ADDENDUM #1

Rye City School District

Issued for Bid: 2021-01-29

This Addendum No. 1 forms part of the Contract Documents and modifies the original bidding documents dated, January 19, 2021.

DATE: 12/18/19
PROJECT No: 9200
DRAWING BY: BGA
CHK BY: BGA
DWG No: E2-304

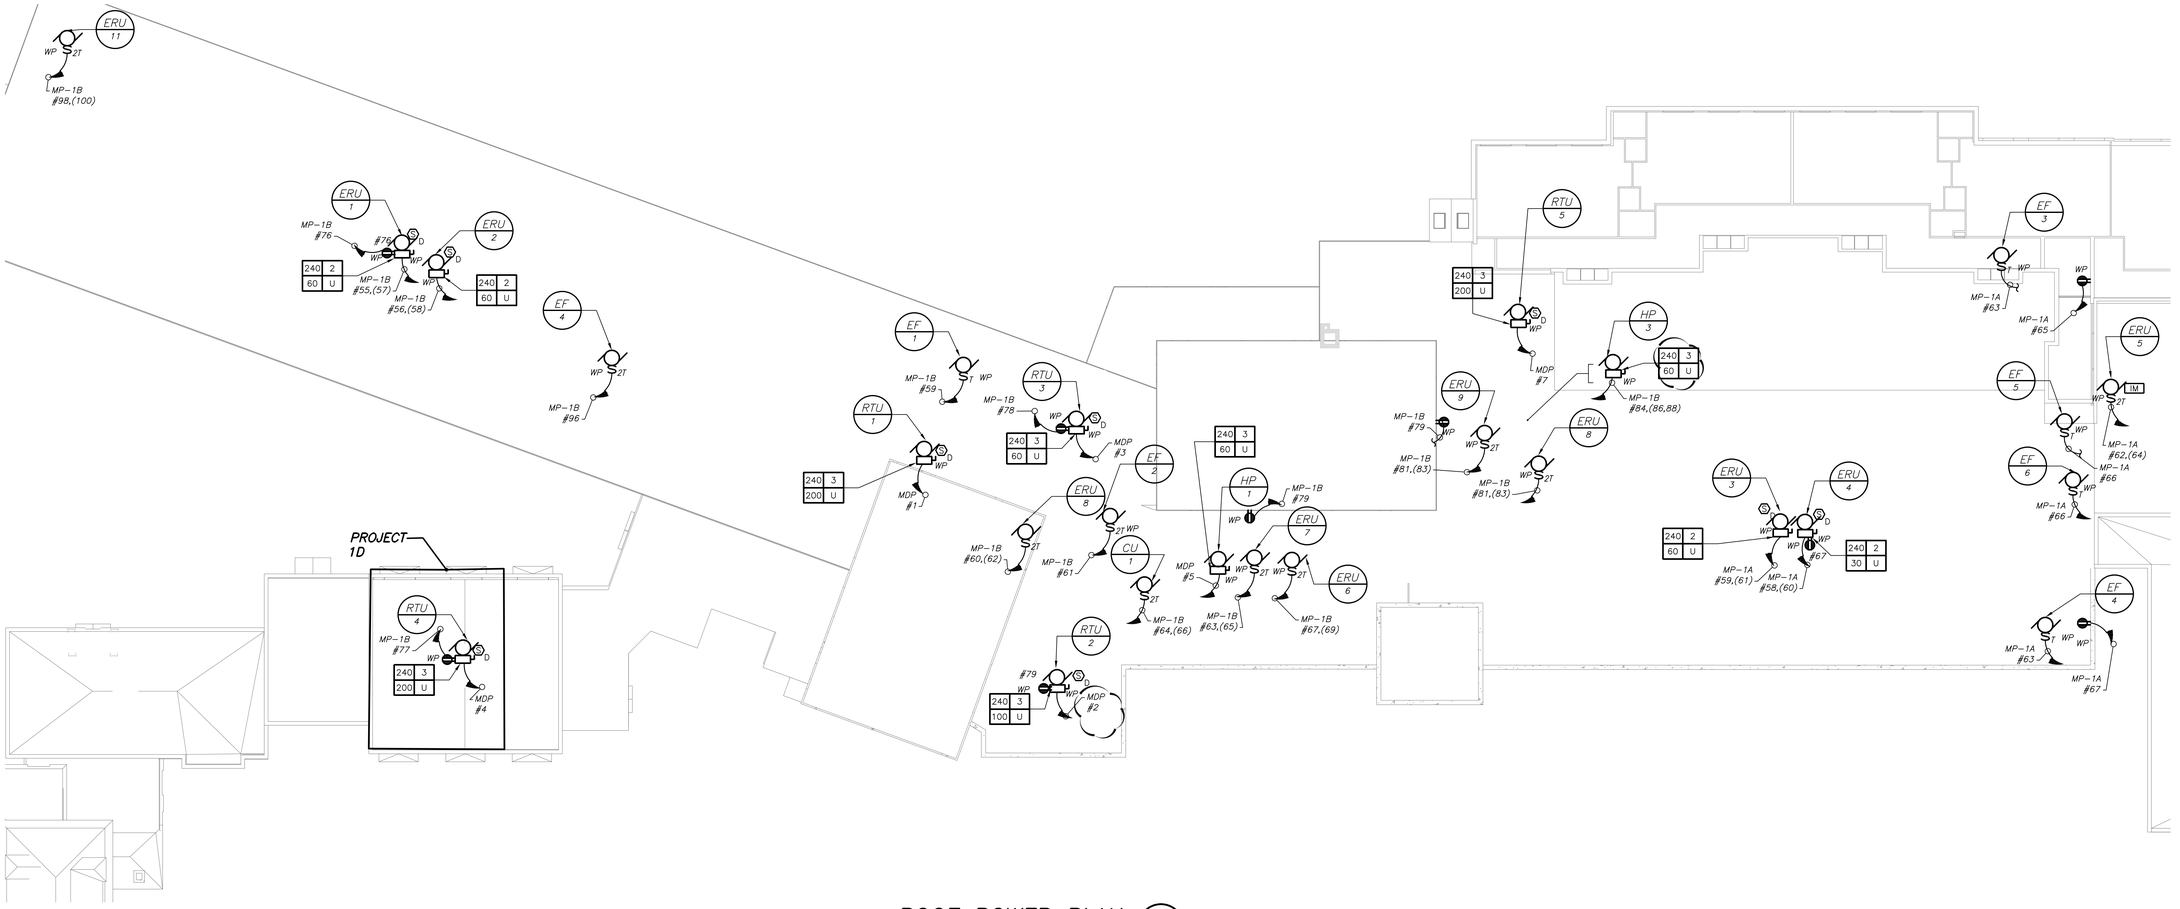
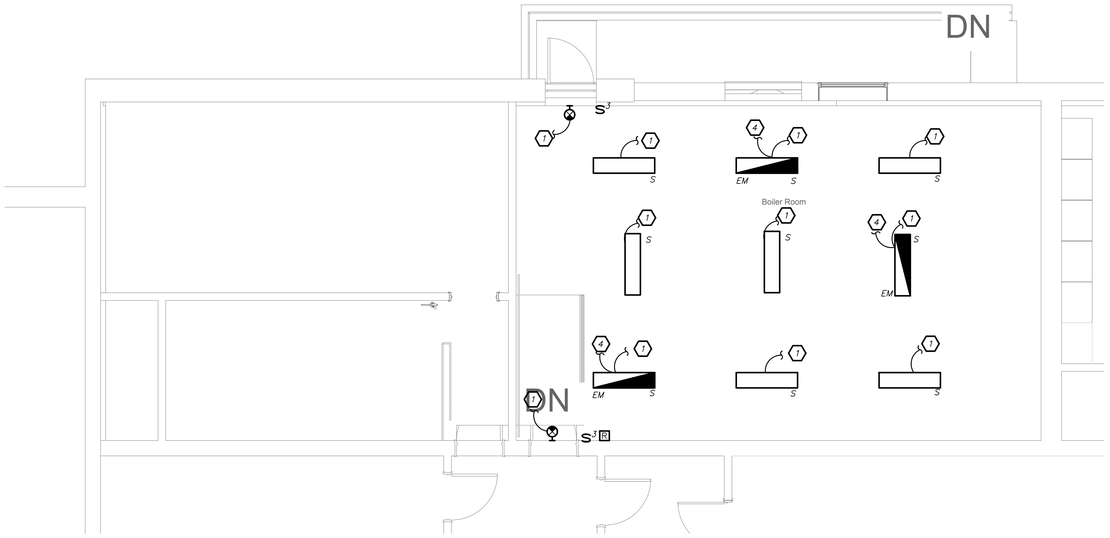
1. Refer to Revised drawing: E2-104 Grey Box Electrical Removals, Lighting, Power, And Fire Alarm Plan-Project 1B.
2. Refer to Revised drawing: E2-202 Partial First Floor Lighting Plan-Project 1A, 2.
3. Refer to Revised drawing: E2-203 Partial First Floor Lighting Plan-Project 1B.
4. Refer to Revised drawing: E2-303 Partial First Floor Power and Fire Alarm Plan-Project 1C.
5. Refer to Revised drawing: E2-304 Roof Power and Fire Alarm Plan-Project 1D.

DATE:	11/07/19
PROJECT No:	9200
DRAWING BY:	KSK
CHK BY:	JFB
DWG No:	C2-001

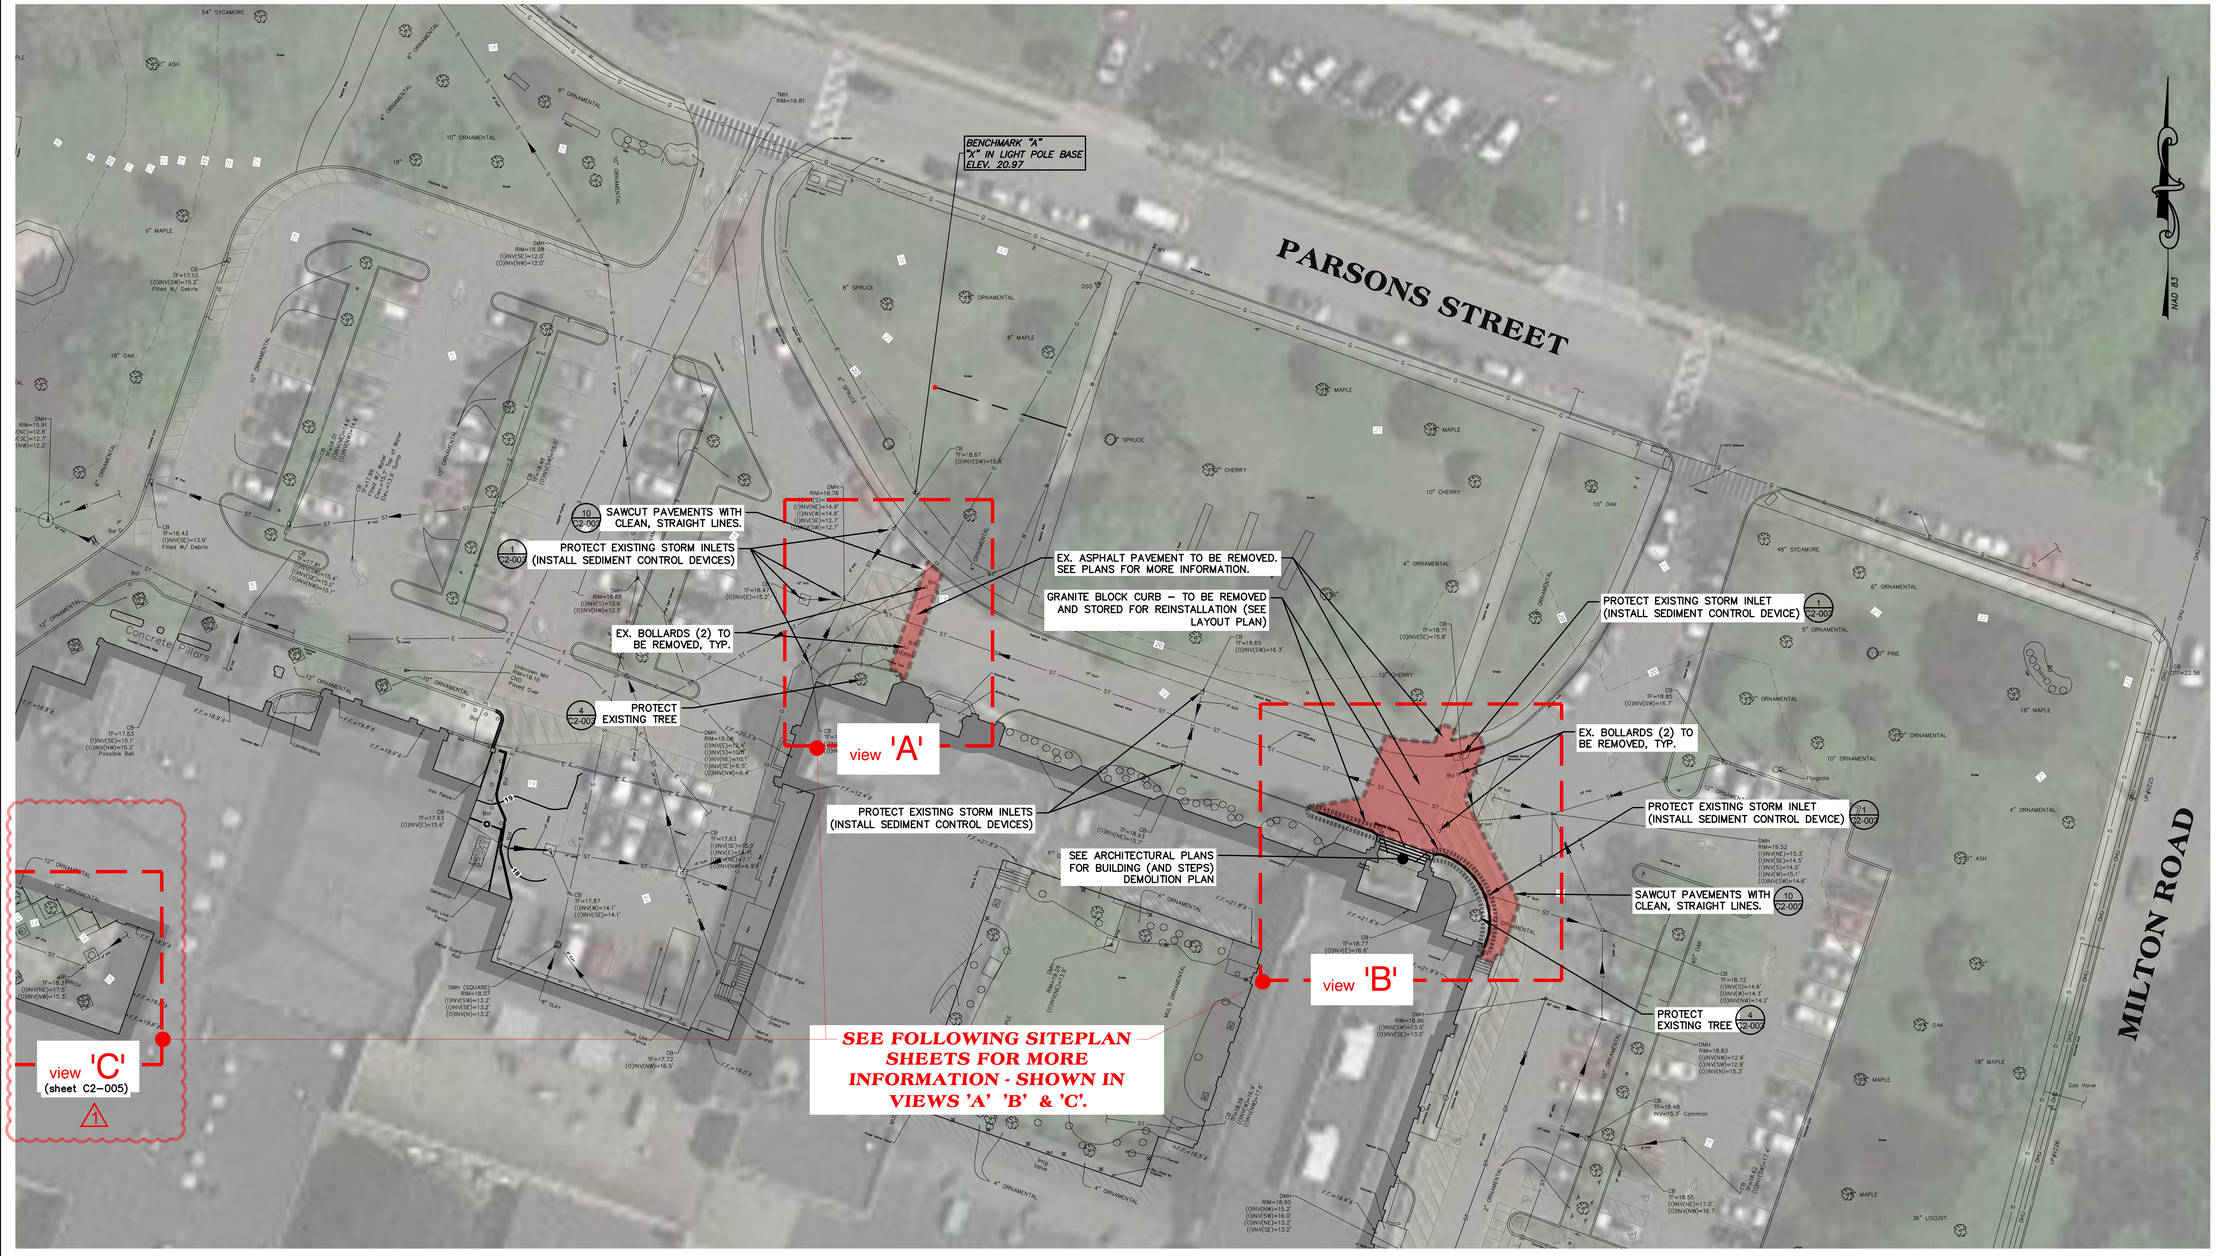
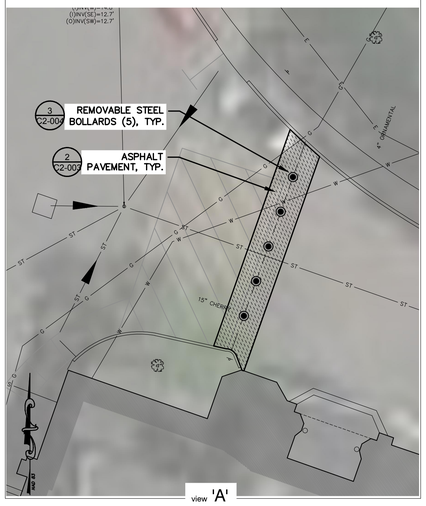
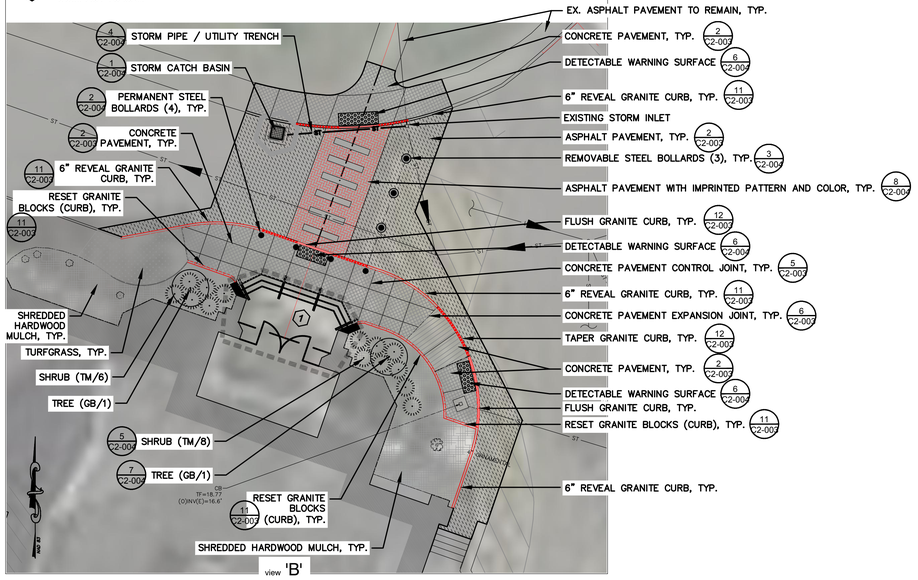
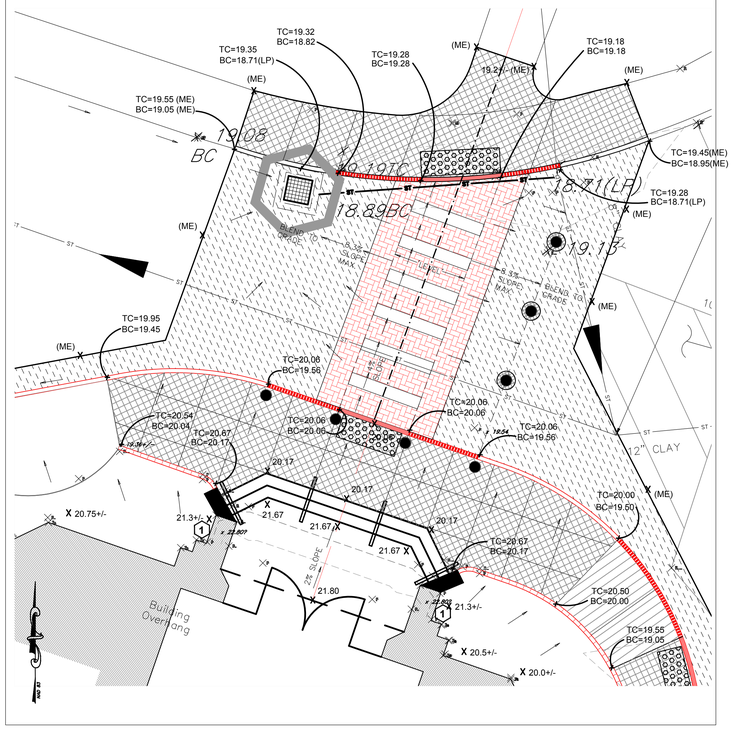
2. C2-001:
    a. Site plan revised to show added scope as part of Project 2.

DATE: 11/07/19
PROJECT No: 9200
DRAWING BY: KSK
CHK BY: JFB
DWG No: C2-005

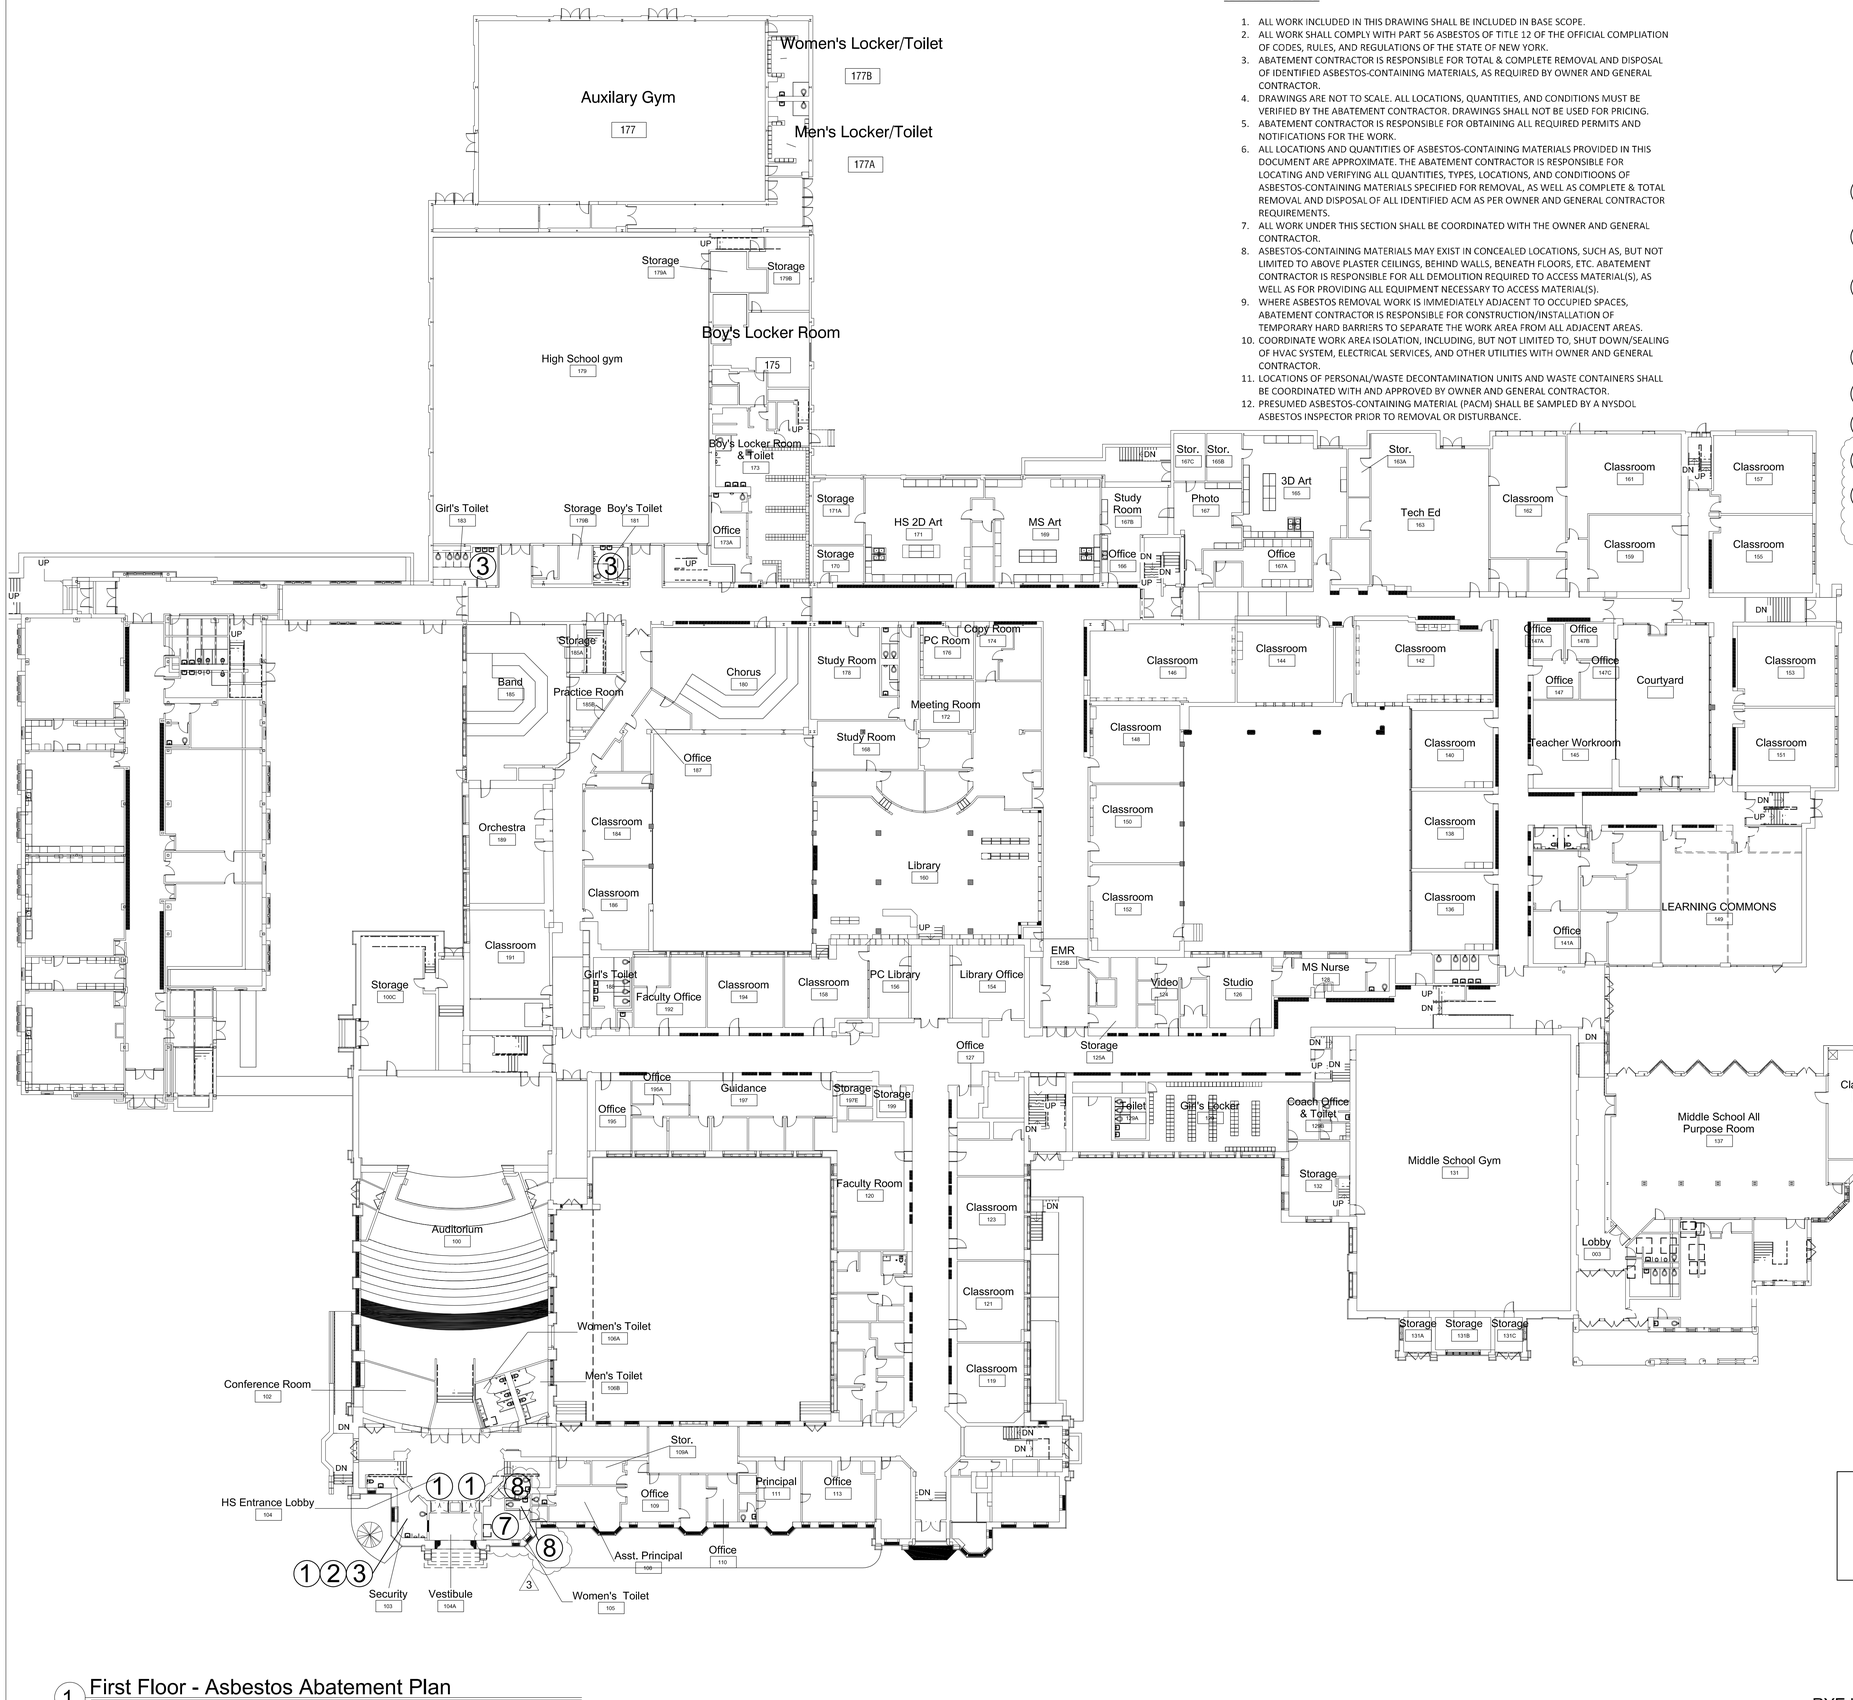
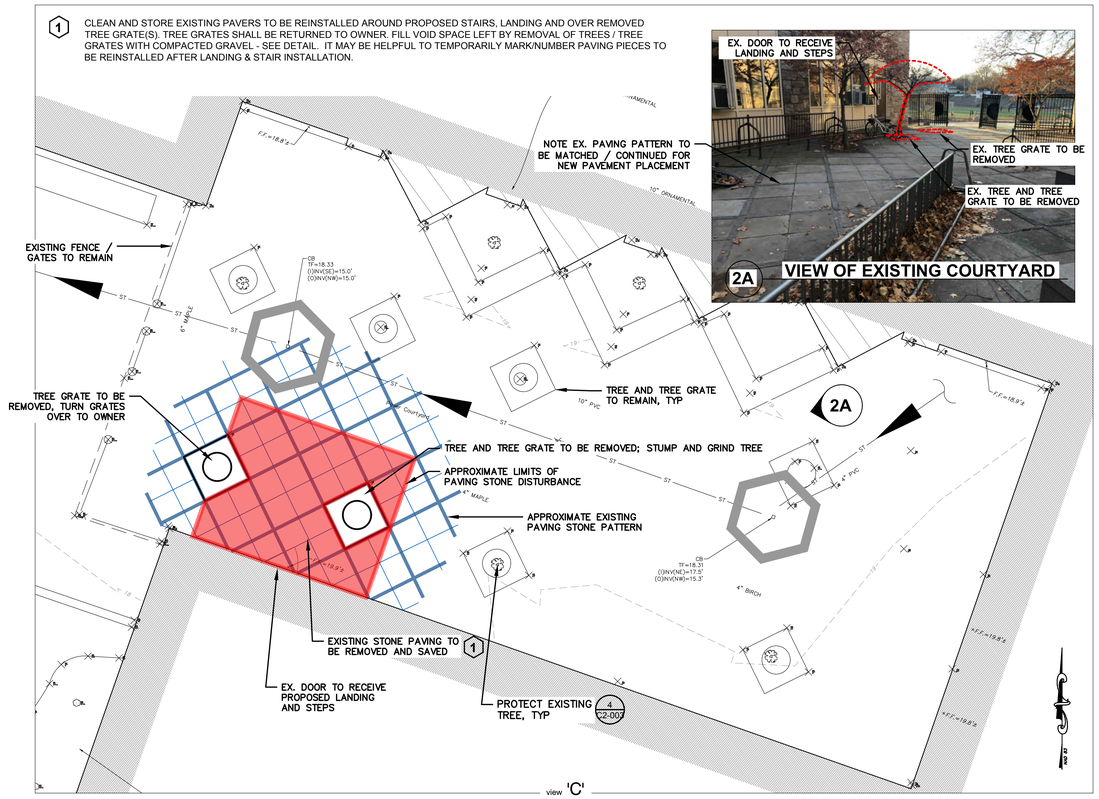
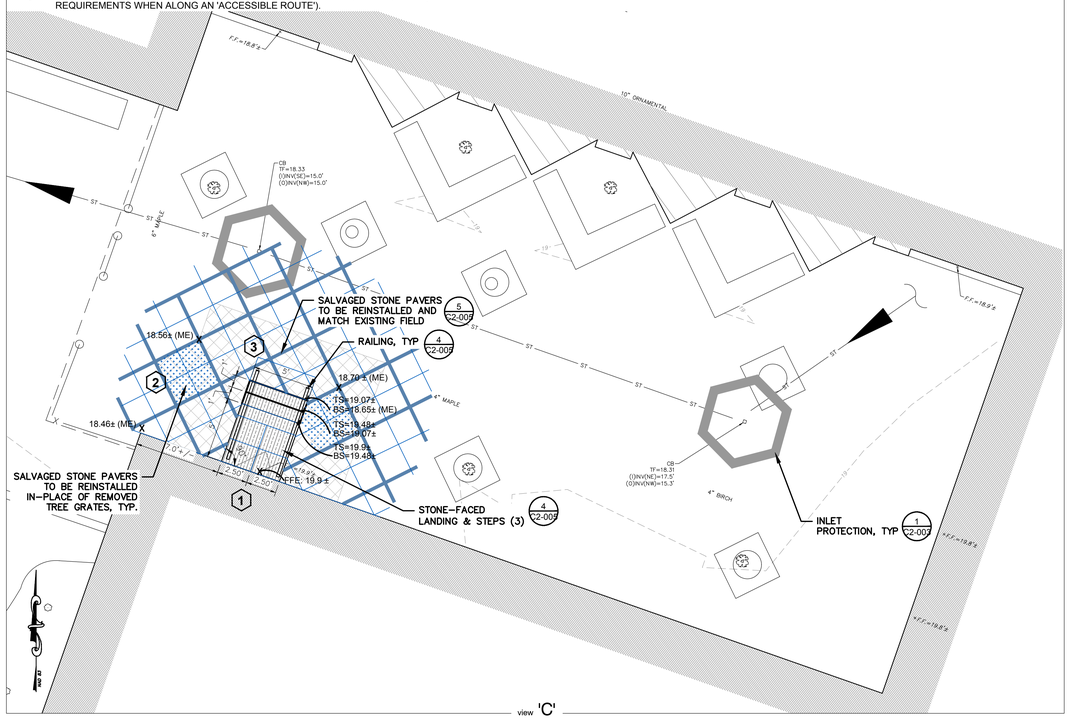
6. C2-005:
    a. New sheet to show added stairs and landing at existing exterior door as part of project 2.
